RE: MODIFICATION TO MP 11\_0089
OLD CLARE HOTEL (20-24 BROADWAY & 1-3 KENSINGTON STREET, CHIPPENDALE)

This submission is written on behalf of the owners of Strata Plan 88765 (3 Carlton Street, Chippendale or as known as One Central Park East (the **adjoining property owners**) in respect of the proposed Section 75W amendment of instrument approval MP 11\_0089 at 20-24 Broadway and 1-3 Kensington Street, Chippendale or as known as the Old Clare Hotel (the **site**).

Figure 1 – The proximity of the rooftop terrace and pool to the adjoining property owners

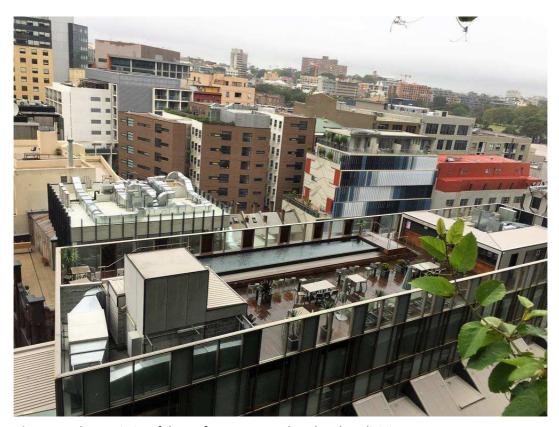
The relative proximity of the existing rooftop terrace and its pool to the north east facing apartments (Level 9 in this instance) at One Central Park East is provided at **Figure 1**. The typical design of these apartments and their private open space is shown at **Figure 2**.
